**Final Plat of
Elk Run First Addition
Sedgwick County, Kansas
September, 1998**

Re: S/D 98-43 - Final Plat of ELK RUN 1ST ADDITION

CASE NUMBER: S/D 98-43 - ELK RUN FIRST ADDITION

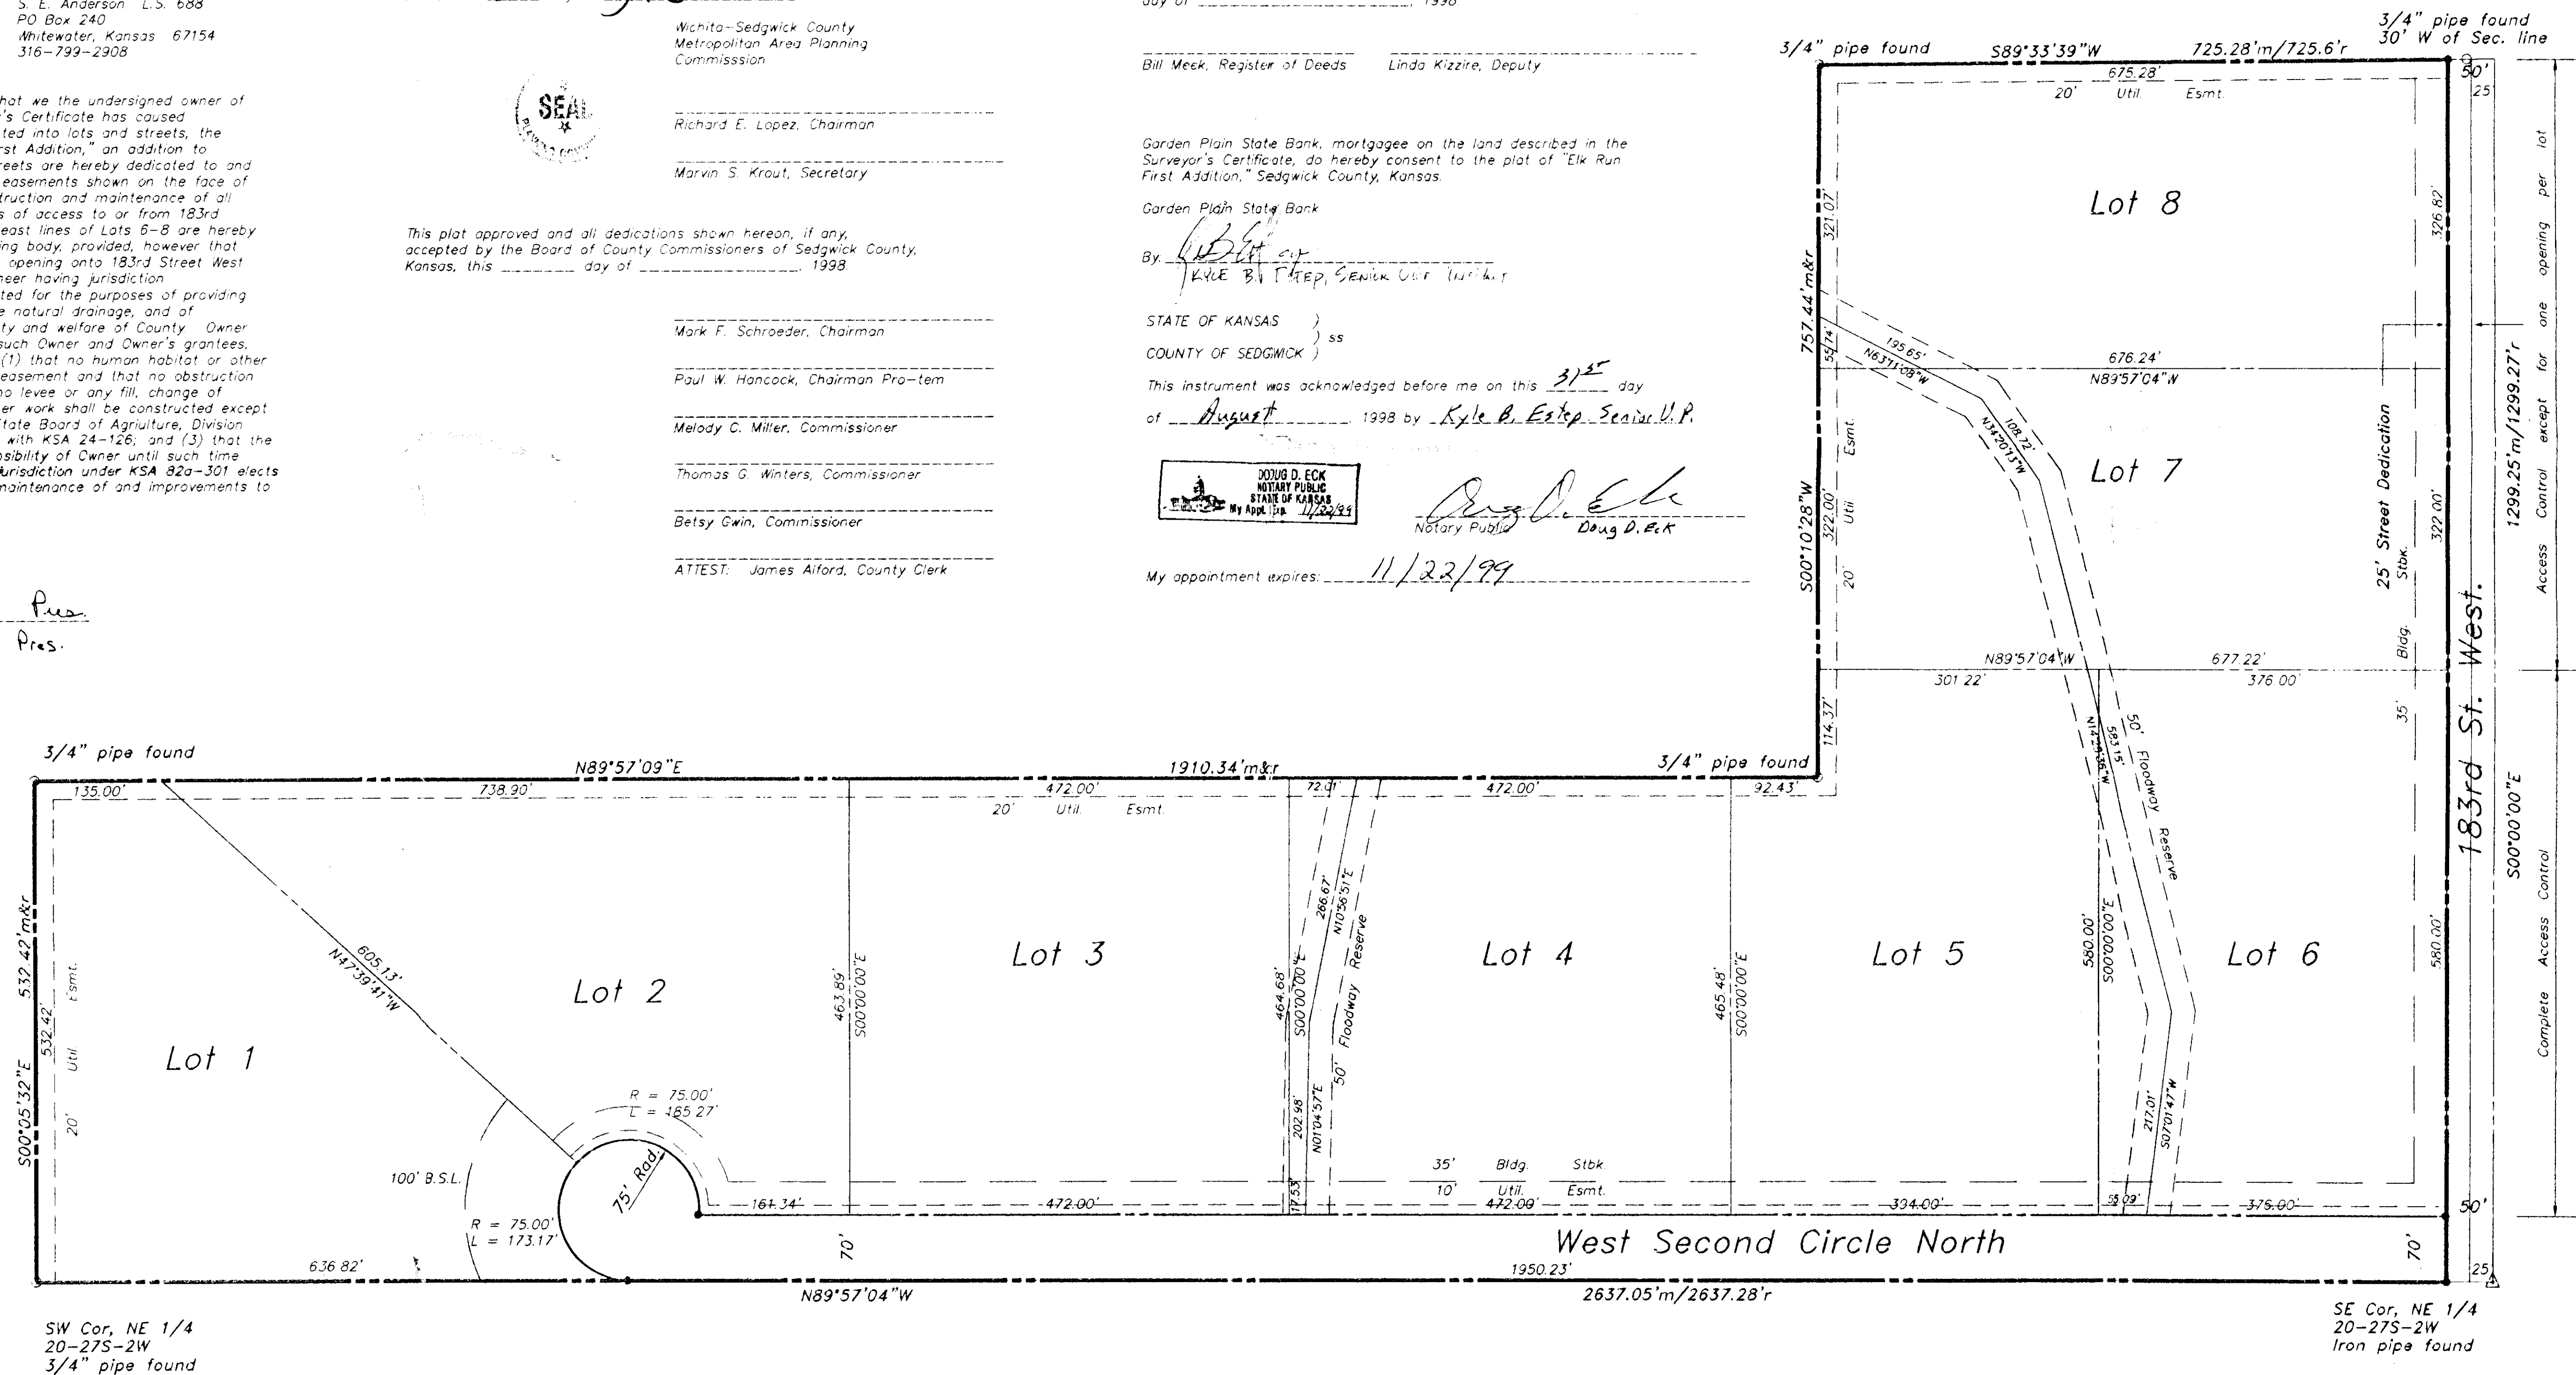
C. *County Engineering* needs to comment on the status of the applicant's drainage *concept. The drainage concept is approved. Floodway reserves should replace the drainage easements and follow the natural swales.*

The requested floodway reserves have been platted; *however distances and bearings need to be added. County Engineering* needs to comment on the status of the applicant's drainage plan. *The drainage plan is approved.*

D. *County Engineering* needs to comment on the need for access controls along 183rd St. West in addition to the need for any improvements to 183rd Street West. *One opening per lot will be permitted for the lots 7 and 8. Lot 6 should have complete access control along 183rd Street.*

E. MAPD recommends a revised lot layout with Lots 7 and 8 oriented toward the road adjoining

the plat to the north. This would eliminate access from the section line road. *The plat is approved as shown, as the street to the north is a private street.*

- F. The applicant shall guarantee the installation of the proposed interior street to the *36-ft rock standard.*
- G. The Subdivision regulations limit the length of cul-de-sacs to 1,200 feet for five-acre lots. The new street within this plat contains a length of 1,900 feet. County Fire needs to comment on the acceptability of the street length.

- H. The applicant needs to revise the legal description to accurately portray the land being platted. The distances on the drawing must be identical to those in the legal description.

- I. The name of the Deputy should be revised to read, "Linda Kizzire".
- J. The applicant shall install or guarantee the installation of all utilities and facilities which are applicable and described in Article 8 of the MAPC Subdivision Regulations. (Water service and fire hydrants required by Article 8 for fire protection shall be as per the direction and approval of the Chief of the Fire Department.)

The final plat has denoted the requested access controls.
